Docket Number:	11-AFC-04
Project Title:	Rio Mesa Solar Electric
TN #:	233553
Document Title:	Applicant's Supplemental Response to Data Request 16 and 26 Additional Information Regarding Traffic and Transportation
Description:	N/A
Filer:	Marichka Haws
Organization:	California Energy Commission
Submitter Role:	Commission Staff
Submission Date:	6/19/2020 3:08:17 PM
Docketed Date:	6/19/2020

APPLICANT'S SUPPLEMENTAL RESPONSE TO DATA REQUEST 16 AND 26: ADDITIONAL INFORMATION REGARDING TRAFFIC AND TRANSPORTATION

In this section of Applicant's Supplemental Response to CEC Staff Data Requests 16 and 26, Applicant describes the changes to the Traffic and Transportation section that will result from the changes to the Project Description relating to the removal of Unit 3. Per staff's request, Applicant uses a strike-out/underline format to identify changes to the Traffic and Transportation section of the Application for Certification that will result from the changes to the Project Description.

CREATED BY: RC	DATE: 6/25/2012	FIG. NO: 5.12-2.1 (REV)
PM: NC	PROJ. NO: 27651006.50511

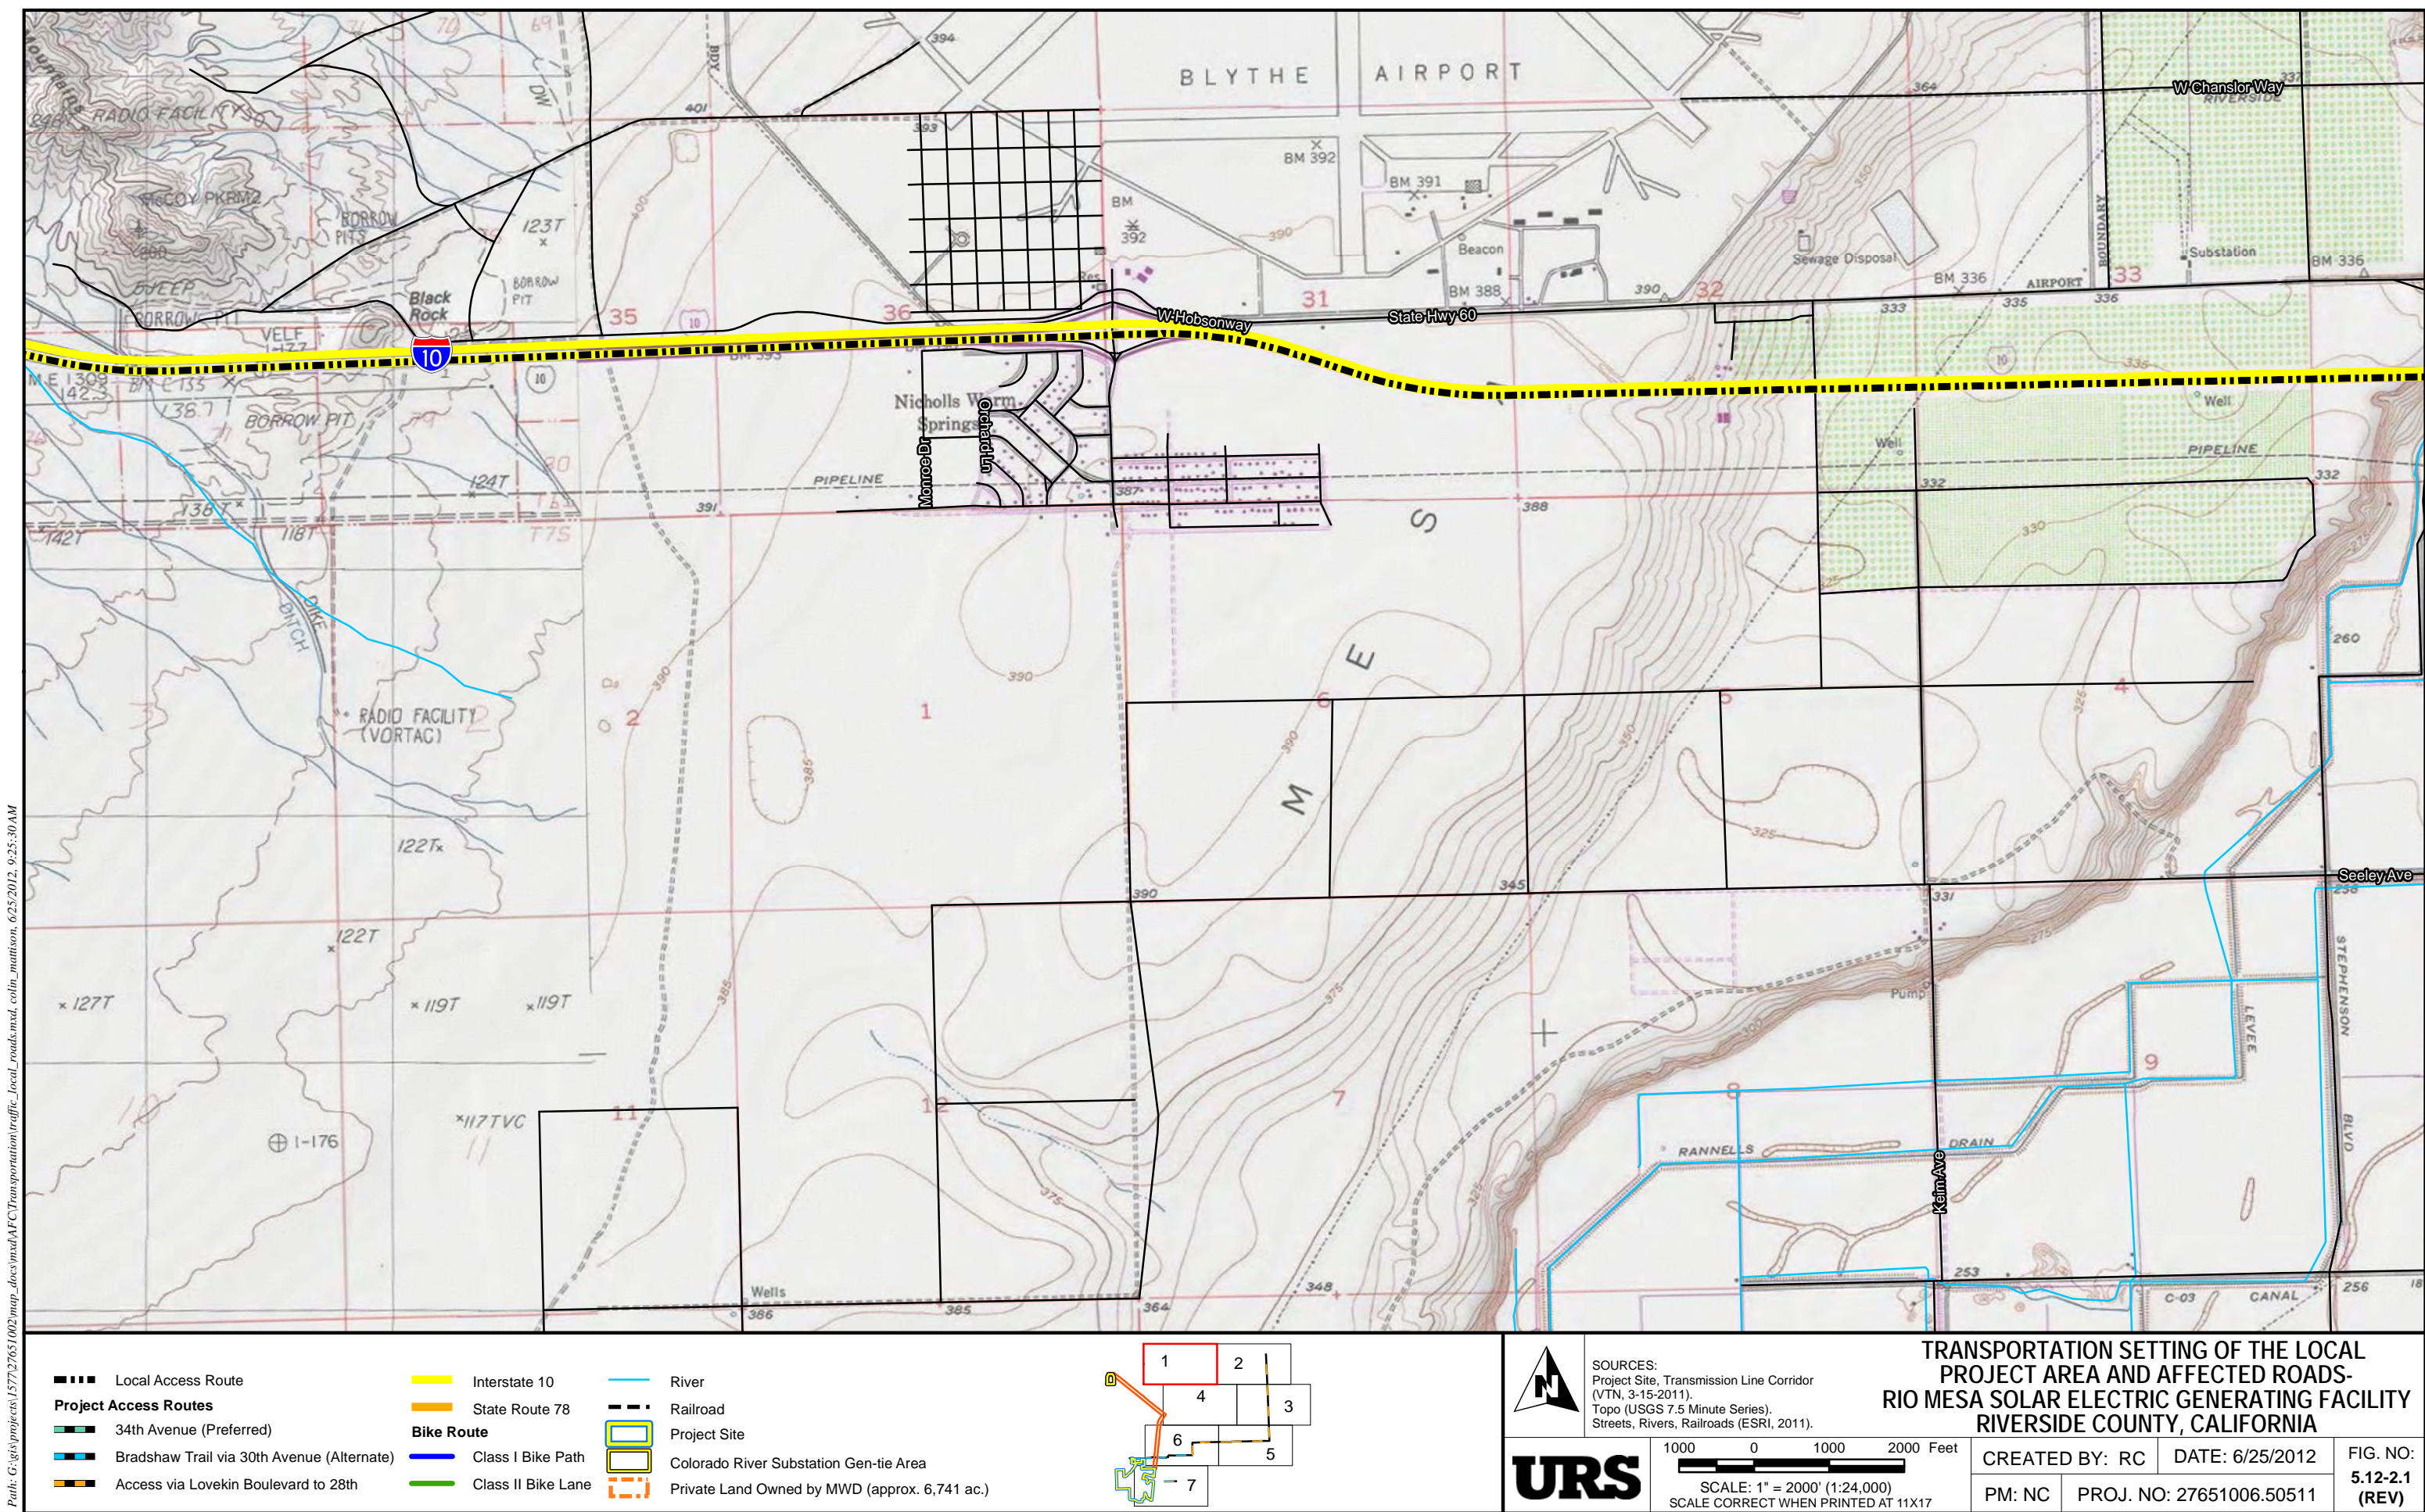
~~30th Avenue~~-Bradshaw Trail ([Preferred access route](#))

~~The preferred access route to the project site is via 30th Avenue which turns into~~Bradshaw Trail ~~as it approaches the site. 30th Avenue~~The portion of Bradshaw Trail that would be used for the preferred [access route](#) is [currently](#) a two-lane, east-west paved road for 1 mile west of Rannells Avenue (State Route 78). The paved portion is 24 feet wide with dirt shoulders. Beyond the paved segment it becomes a graded dirt road that varies in width from 15 to 30 feet as it leads into the project site. County load restrictions are outlined in Section 5.12.2 of this report.

The Applicant has revised the primary access road to Bradshaw Trail subsequent to the removal of RMS-3 and relocation of the Common Area to accomplish the following goals:

- Mitigate construction schedule impacts from the construction of the access road across the major wash in initial phase of the construction. While the road construction would be on-going, Applicant would need to utilize Bradshaw Trail anyway. This also bolsters compliance with the Purchase Power Agreement (PPA) schedule requirements.
- Reduce environmental impacts on the major wash that is south of the Construction logistics area. New 34th avenue road configuration impacts only 10-20 percent of wash flow where original road path impacted about 80 percent of the flow.

FIG. NO:
5.12-7
(REV)

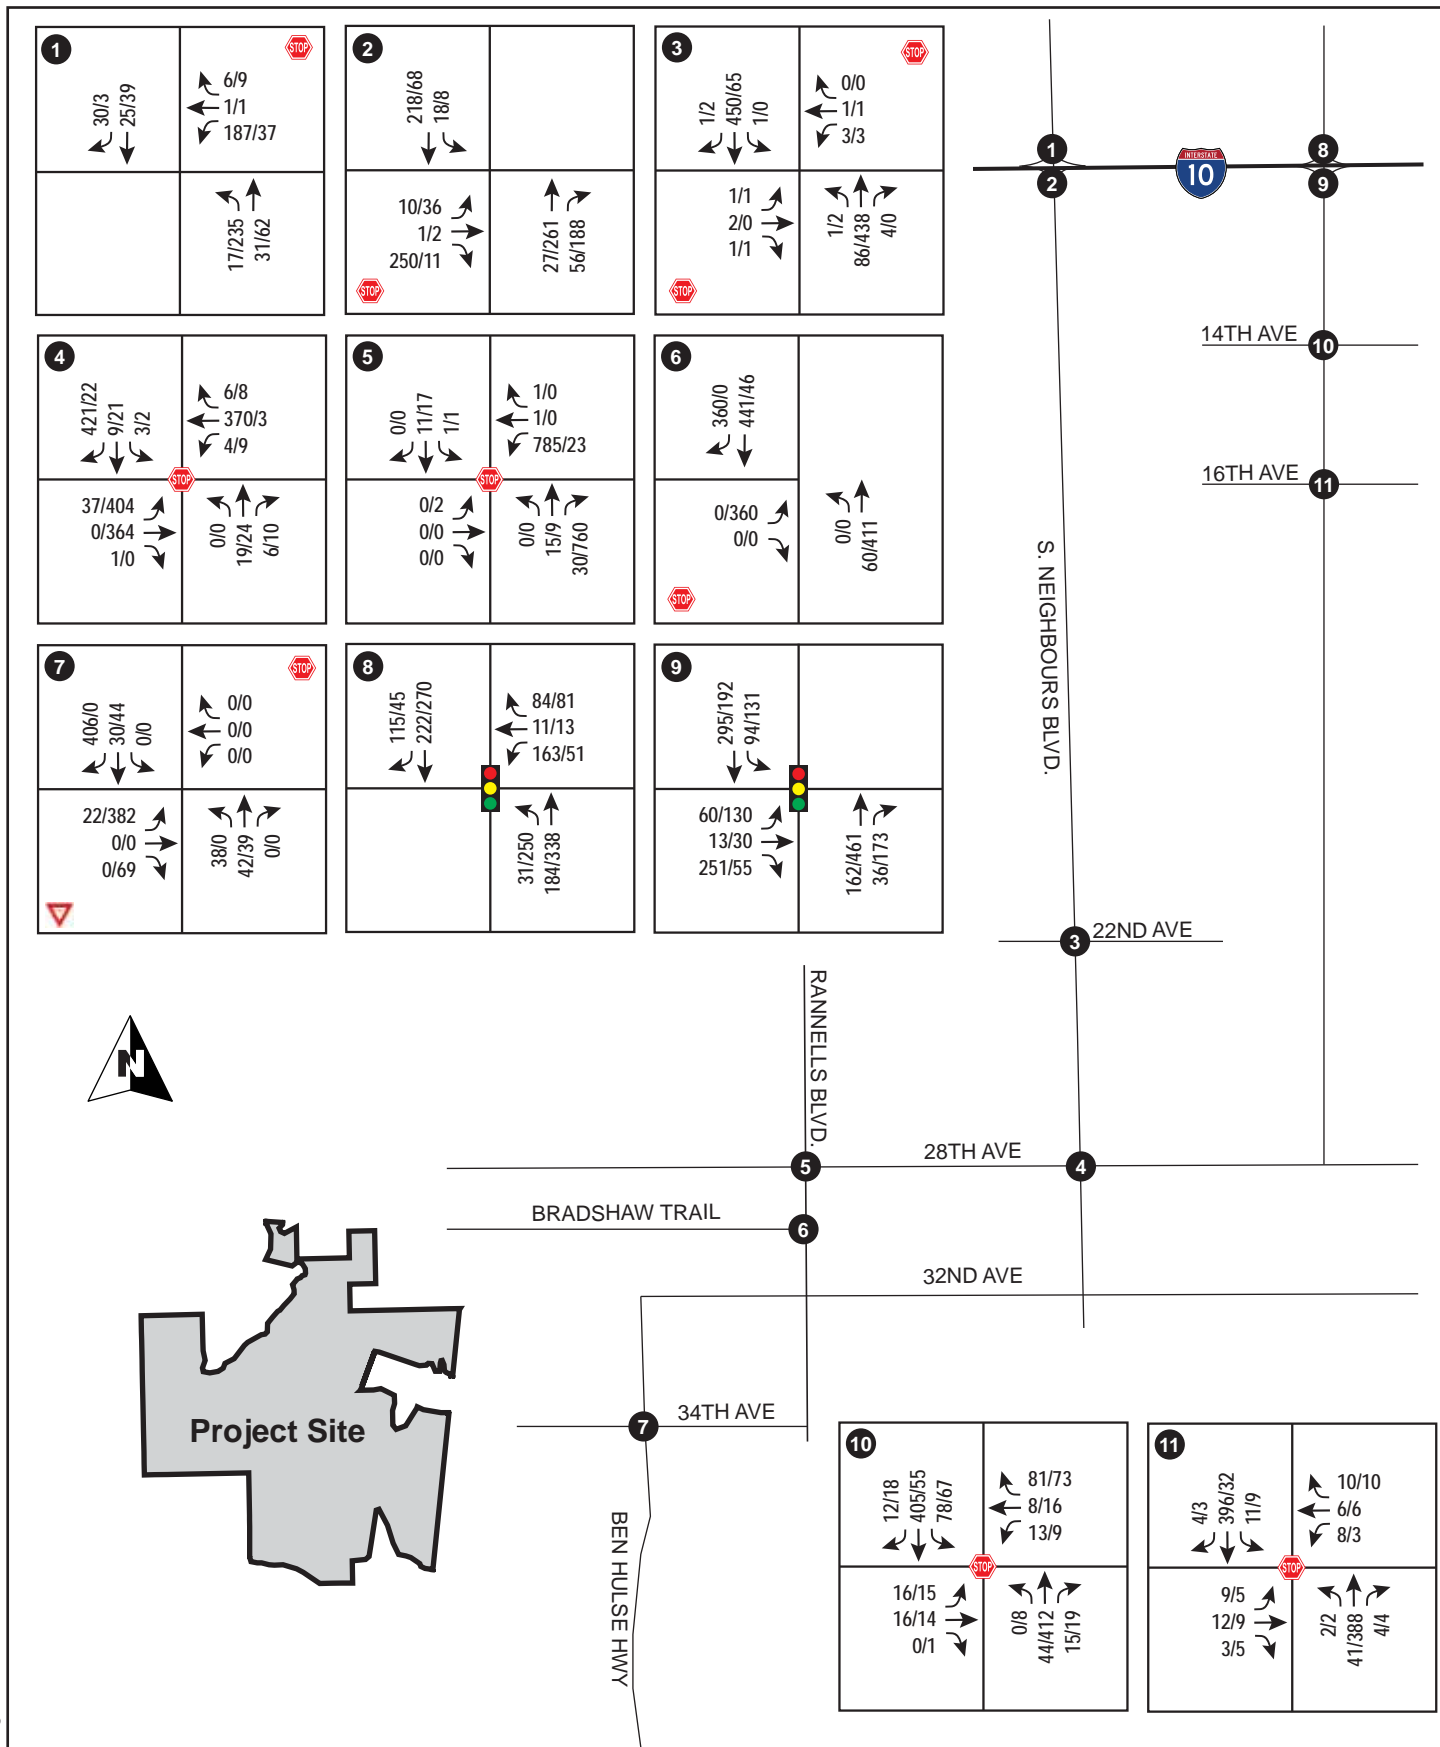
Table 5.12-10 presents peak hour intersection LOS and average vehicle delay results under Year 2015 project construction conditions. The LOS Calculation worksheets are provided in Appendix 5.12B. Figure 5.12-7 [\(rev\)](#) shows Year 2015 Project Construction conditions AM and PM peak-hour turning movement volumes for the traffic study intersections.

FIG. NO:
5.12-9 REV

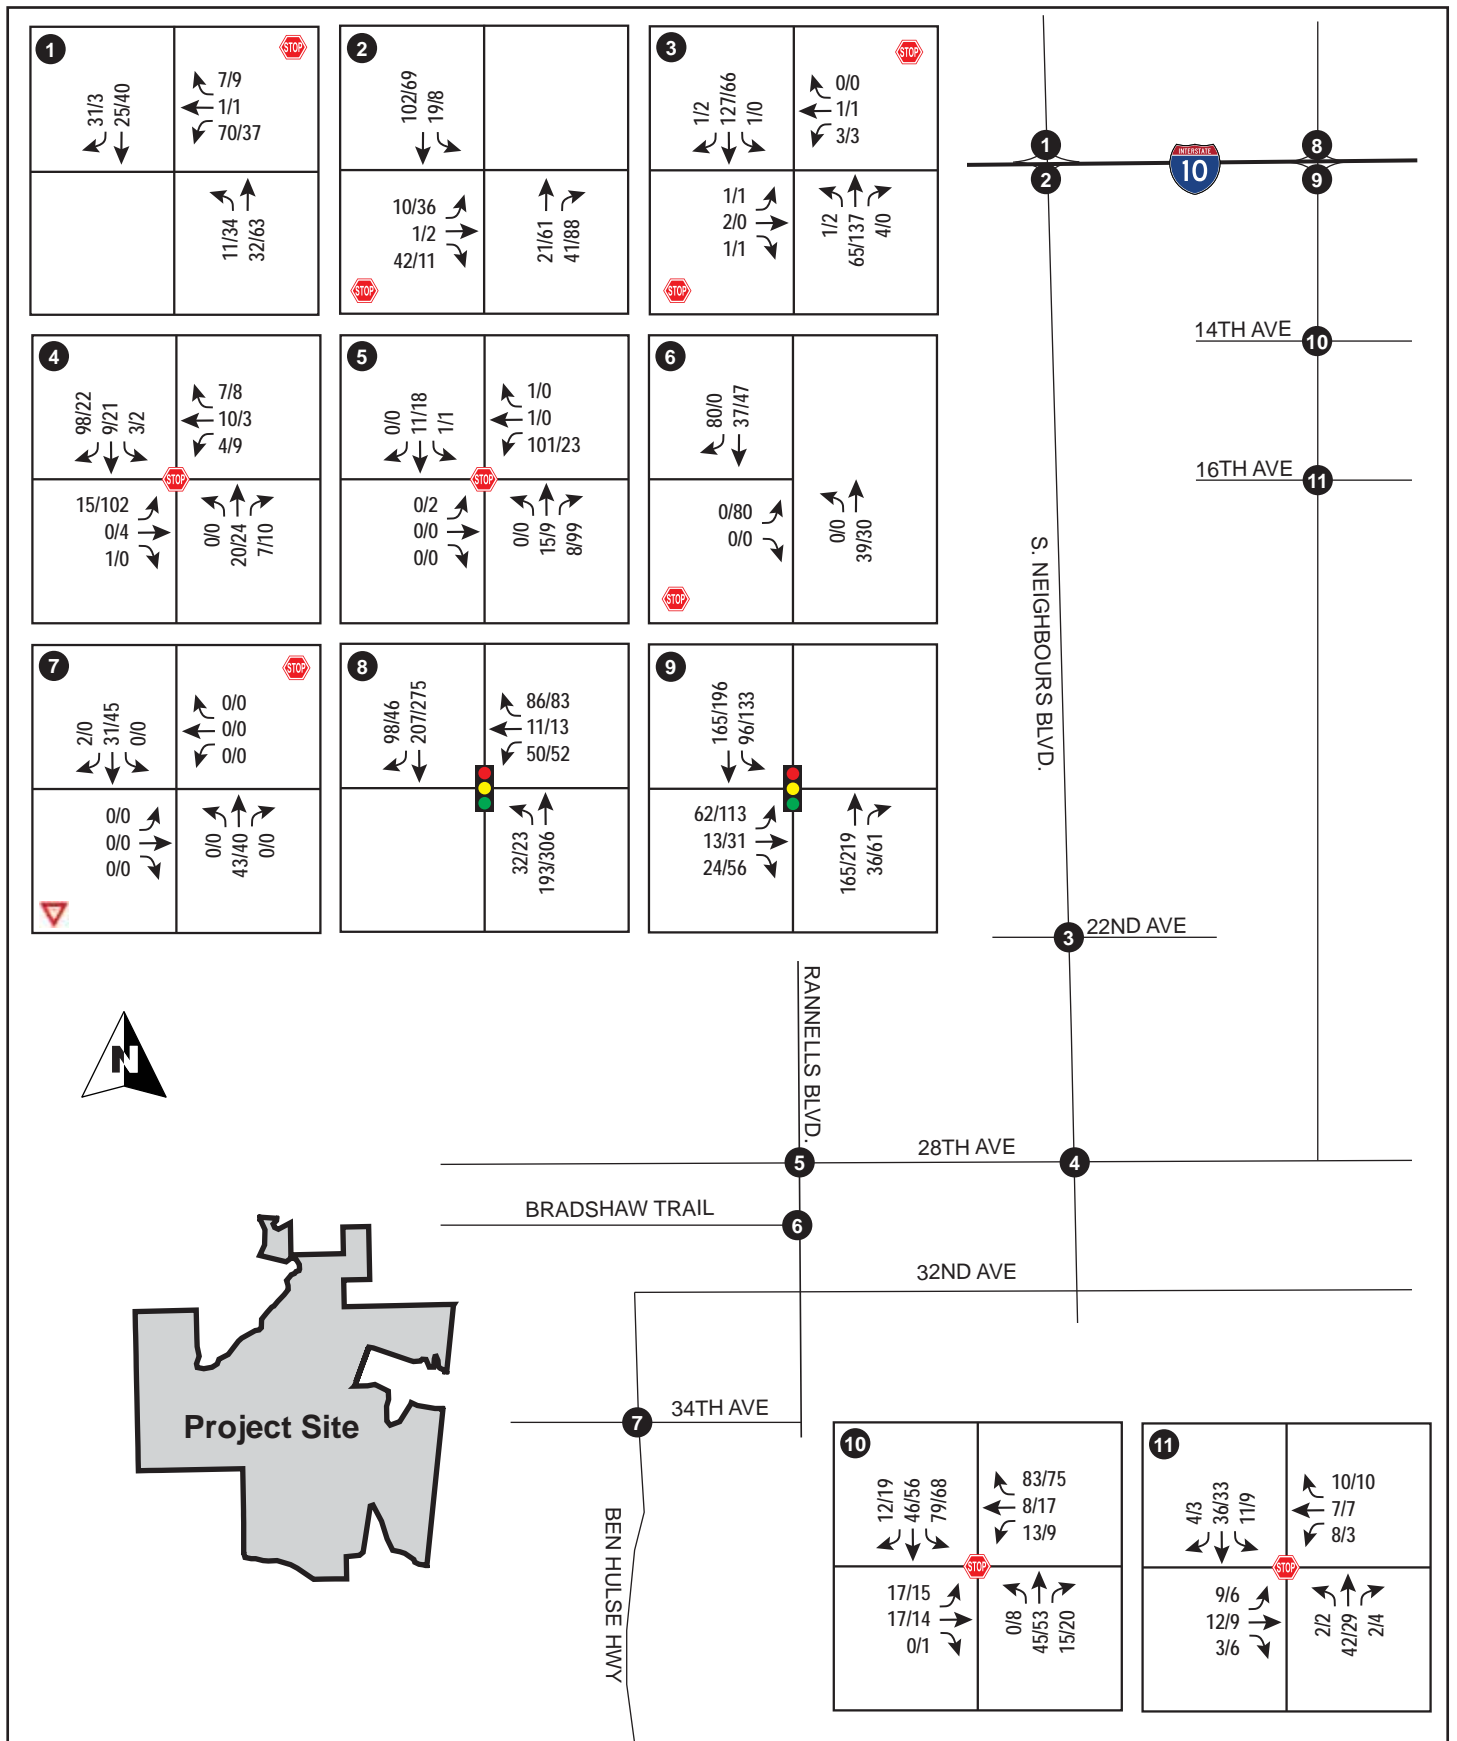
Table 5.12-14 presents the peak-hour intersection LOS and average vehicle delay results under Year 2016 Project Operations conditions. The LOS calculation worksheets are provided in Appendix 5.12B. Figure 5.12-9 [\(rev\)](#) shows Year 2016 Project Operations AM and PM peak-hour turning movement volumes for the traffic study intersections.
